Staff Report & Recommendation

Design Review Board

SUBJECT: DRB16-0056
1134 South Biscayne Point Road (Parcel 2) – Single Family Home

The graphics below depicts the impact of having two separate driveways for the properties and the single shared driveway.

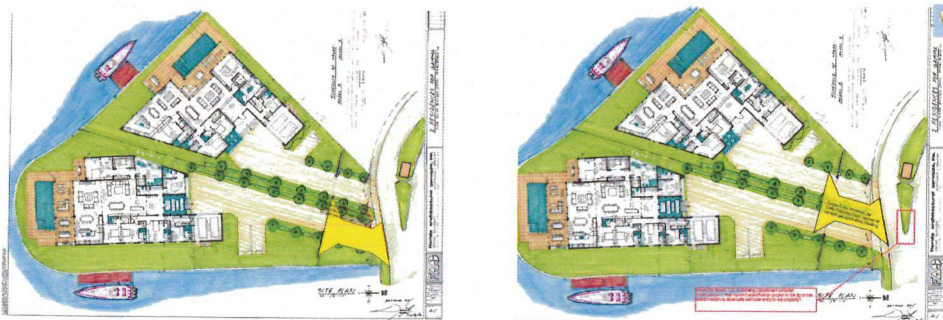
4. A variance to reduce by 4'-0" the minimum required setback of 4'-0" for a driveway in order to construct a driveway at zero setback along the side property line.

In an effort to be least disruptive to the area, the applicant is proposing a shared driveway between this property and the companion application (DRB15-0055: Parcel 1). In order to do so, the driveway must straddle both parcels' shared interior property line. This is the most practical and safest solution in order to have access to and from the new residences created as a result of the lot split. The location of the property entrance to Biscayne Point, with a very narrow front, is a special condition that results in the variance requested, in addition to the existing locations of the guardhouse and the entrance bridge. The proposed driveway must **NOT** create a conflict with the center landscaped median which serves as part of the entry feature to the community currently being renovated by the CIP Department. Again, due to the narrow width of the front property line and irregular shape of the lot, the variance request complies with the practical difficulties criteria.

Original 1925 plat of Biscayne Point

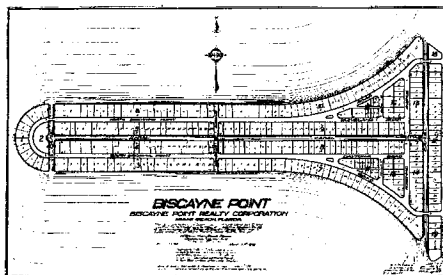
The applicant is requesting several variances for parcel 2, as a result of the lot split of the property. Similar variances are also requested on the adjacent parcel 1. The existing property with an area of 33,538 SF approximately is within the plat of Biscayne Point Subdivision which was originally platted in 1925. The original plat contains two similar irregular shaped edge parcels. The northern parcel of Lot 33 of Block 10 is the mirror image to the subject property (before the lot split). As shown in the images below, in 1955 that lot (Lot 33 of Block 10) was also subdivided into three tracts and platted with access by a private street. In this regard, the subdivision of land, is compatible and in character with the area.

The adjacent lots to the west and north of the subject property are substantially smaller in area ranging from 11,250 sf to 15,300 sf approximately, and based on the minimum area required for the RS-3 district, the site, subject to a lot split, could theoretically be subdivided in three 10,000 SF lots, similar to the mirror properties to the north. However, its location, irregular shape and access to the street, create practical difficulties that make this property unique in size, as it is almost three times larger in area than the surrounding properties and also subject to a more restrictive rear setback. Also, due to its larger area, a more massive and imposing single family home could be constructed, which may negatively affect the neighborhood, as the majority of the homes are one-story structures. Staff finds that the proposed project is more compatible with the neighborhood and would not have an adverse impact in the urban context.
